**HISTORIC PRESERVATION REVIEW BOARD
STAFF REPORT AND RECOMMENDATION**

Landmark/District:	Sixteenth Street Historic District/ Christian Science Monitor Building	(x) Agenda
Address:	900 16th Street, NW	() Consent Calendar
Meeting Date:	May 24, 2012	(x) Demolition
H.P.A. Number:	12-035	(x) New Construction
Staff Reviewers:	David Maloney, Steve Callcott	(x) Conceptual Design

The Third Church of Christ, Scientist (Third Church) and ICG 16th Street Associates, LLC (ICG) seek review of the design concept for a new structure to replace the existing Third Church and Christian Science Monitor Building. These buildings are listed together as a historic landmark in the DC Inventory of Historic Sites, and the property lies within the Sixteenth Street Historic District, although the buildings are considered non-contributing to the district.

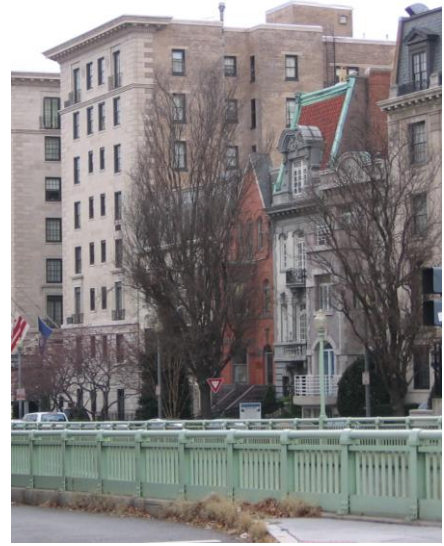
While it is certainly true that the proposed extra floor is not as anomalous as the three floors originally proposed, it would nonetheless be visible from the street in a way that would make it apparent the building did not follow the same urban design rules applied to its neighbors. In View 12 of the submission, for example, the top floor and elevated penthouse are easy to see, and would be even more visible further east along K Street. In the 16th Street elevation drawing and in View 23, the jump in cornice height above its immediate historic neighbor to the north, the World Center Building, is obvious. While some of the nearly 8-foot misalignment is due to the slope in street grade, the effect is of a discordant or unplanned design relationship, as opposed to the harmonious relationship of height and mass that the existing Monitor Building achieves. And it hardly needs to be said that the advantage of shielding the recessed upper floor by projecting above the established cornice height would disappear if the extra floor did not exist.

The staff recommends that the Board find the proposed construction in excess of the 90-foot height limit to be incompatible with the character of the Sixteenth Street Historic District and the urban design character of a major contributing element of the L'Enfant Plan.

The staff further recommends that the Board encourage the applicant to revise the project within existing height restrictions and to strengthen its design compatibility with the historic context.
